Sub: Technical Audit Report No. RDSO/2025/EL/TAR/0038 Rev. '0' dated 13.03.2025 on Traction motor (6FRA6068) maintenance at Electric Loco Work-Shop/Bhusaval.

**Technical Audit Report of Electric Loco Work Shop
/BSL for maintenance of three phase locomotive
Traction Motors (TM) type-6FRA6068**

Report No.: RDSO/2025/EL/TAR/0038 Rev '0'

Bearings lying on shop floor

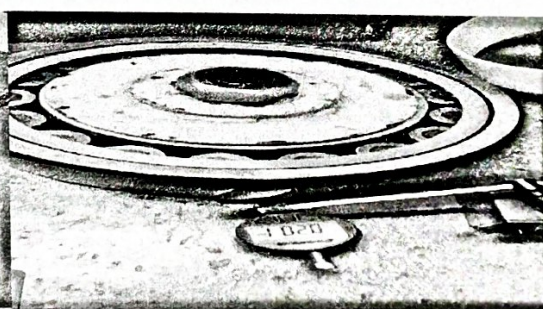
- i) Adjacent to the traction motor assembly area, the bearing storage room is provided. The room has provision of number of concrete shelves for storage of bearings. Bearing boxes were found lying on floor of the room instead of properly stacking in shelves. It was advised that practice of FIFO (first in first out) is being followed but no such demarcation has been done. The bearing storage room was provided with two number split AC's and both were found in working condition and the room was sufficiently cool.

Outer labyrinth seating dia Inner racer seating dia Inner labyrinth seating Snap dial gauge

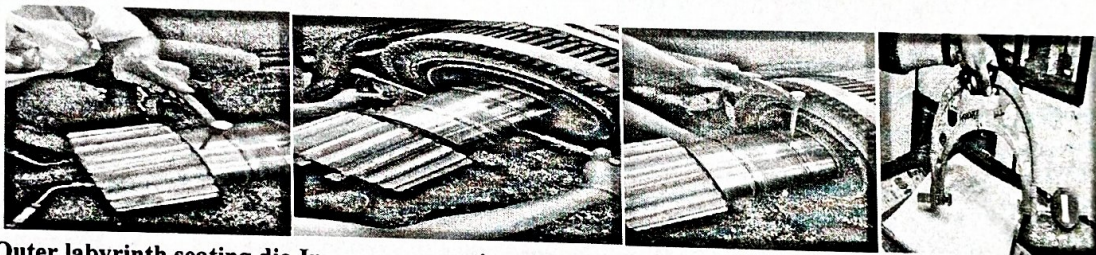
- iv) During assembly, components were checked with bore dial gauge and two point outside micrometers with least count of 1 micron. Details of measured dimensions during audit and specified standard dimensions are provided below:-

Faulty rotor balancing Machine.

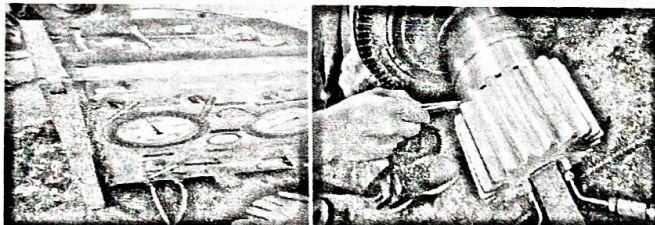
- i) The practice of rotor balancing was not getting ensured during POH by the rotor weight balancing machine at the TM assembly section as balancing machine were found in faulty condition same required to be rectified and recommissioned.

- vi) The rotor weight balancing machine was observed to be faulty and rotors were not getting dynamically balanced during overhauling. Balancing machine required to be rectified and recommissioned by the POH shop.

Inductance measurement of assembled TM

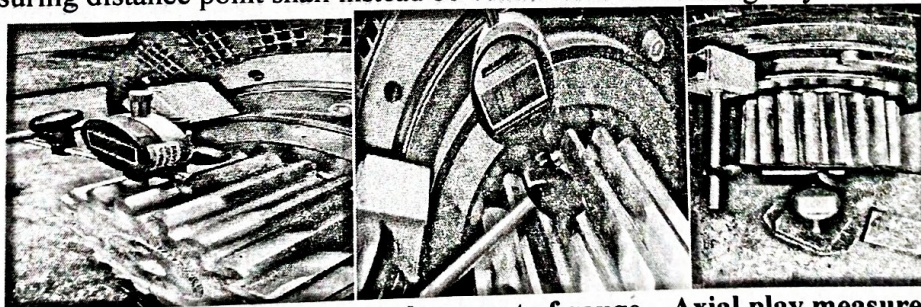
- ii) Tests on Rotor:- To detect the broken bar of a rotor, growler test is also performed on the rotors as informed by POH/BSL.
- ii) Light Run test on assembled TM:-
During the light run test first the Traction Motor is rotate at lower of 200- 400 rpm for 5 minutes .Thereafter the TM was run at 1000 rpm with 50Hz supply. During the light run test the phase currents were 15.0 A, 14.5A,14.7A . The Traction motor was run in clockwise as well as anticlockwise direction for one hour (01 hour) each and bearing temperatures at the end of the light run tests were observed. As per POH/BSL the bearing temperature rise shallremains less than ($< 25^{\circ}$ Ambient).

- i) During the light run test the TM shall be run at 100 rpm for 5-10 minutes so that the grease is uniformly distributed along the entire bearing . Thereafter the TM shall be run on 1000 rpm and not beyond this point vibration and bearing temperature shall be monitored. Vibration and noise shall be as per IEC 60349-2 values. Preferably the TM shall be run in both the directions upto 30 minutes.
